Technical Bulletin

C521BEE

Product: DVD Player Hardware Technical Bulletin:C521BEE-H2005-04

Date: June 27/05 Subject: Laser ribbon cable

Figure 1

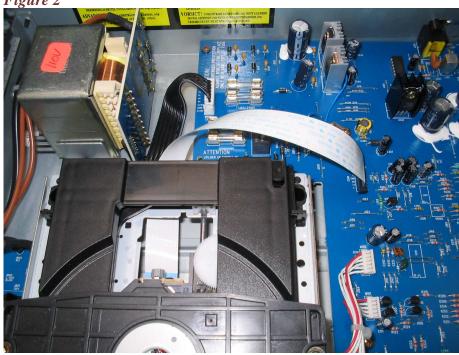
DESCRIPTION: You may have the complaint that some tracks skip or stops playing altogether.

REASON: The laser pick up connects to the main pc board via a flat ribbon cable and possibly is twisted the wrong way. It maybe getting caught on the fuse holders or other parts. just behind the transport mechanism. See figure 1.

INCORRECT

SOLUTION: The ribbon cable needs to be allowed to wrap smoothly as shown in figure 2.
